Access Compliance Report

Public Rights-of-Way

(Curb Ramps)

Intersection ID: 30303	Main Street: HAVEN_CROSS_LN	Cross Street: MUMFORD_LN	Location: SW
ADA ID: C63C9EC6A54A	Ramp Type: PerpDiag	Initial Pass/Fail: Fail	Overall Compliance: No
Severity Score: 13.75			
Codes/Mitigation Info/Possible Solution		Field Measurements/Component Compliance

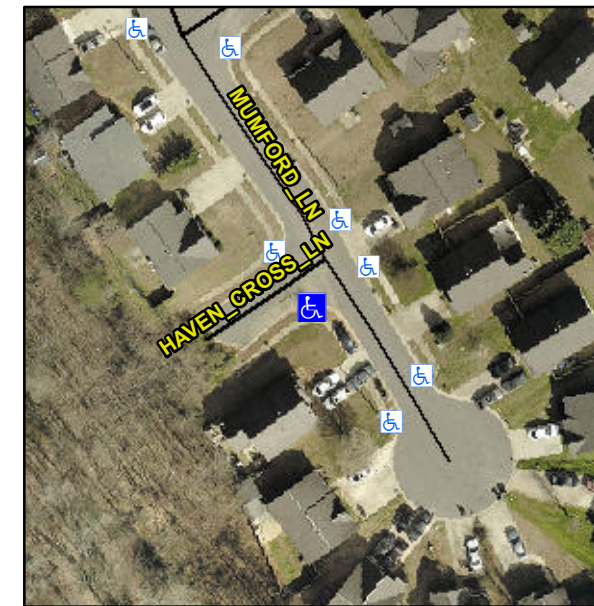
Not Found, R304.2.2, R304.5.3

Compliance	Description	Data	Compliance	Description	Data
N/A	Ramp Length (in)	48.5	No	Ramp Slope (%)	10.4
Yes	Ramp Width (in)	48.0	No	Ramp XSlope (%)	4.0
N/A	Flare Type LT	N/A	N/A	Flare Type RT	N/A
N/A	Flare Slope LT (%)	N/A	N/A	Flare Slope RT (%)	N/A
N/A	Flare Traversable LT?	N/A	N/A	Flare Traversable RT?	N/A
N/A	Landing Length (in)	N/A	N/A	DWS Provided?	N/A
N/A	Landing Width (in)	N/A	N/A	DWS Contrast?	N/A
N/A	Landing Slope (%)	N/A	N/A	DWS Length (in)	N/A
N/A	Landing X Slope (%)	N/A	N/A	DWS Full Width?	N/A
N/A	Landing Curb? (Y/N)	N/A	N/A	DWS Offset (in)	N/A
N/A	Shared Landing?	N/A			
N/A	Gutter Ponding?	N/A	N/A	Gutter Slope (%)	N/A
N/A	Gutter Lip Ht (in)	N/A	N/A	Gutter X Slope (%)	N/A
N/A	Painted X Walk1?	No	N/A	Painted X Walk2?	No
	X Walk 1 Direction	To NE		X Walk 2 Direction	To NW
N/A	X Walk 1 Width (in)	N/A	N/A	X Walk 2 Width (in)	N/A
	X Walk 1 Slope (%)	2.7		X Walk 2 Slope (%)	1.2
	X Walk 1 X Slope (%)	1.4		X Walk 2 X Slope (%)	0.3

Remove & Replace Curb Ramp With Two New Directional Ramps or Equivalent.
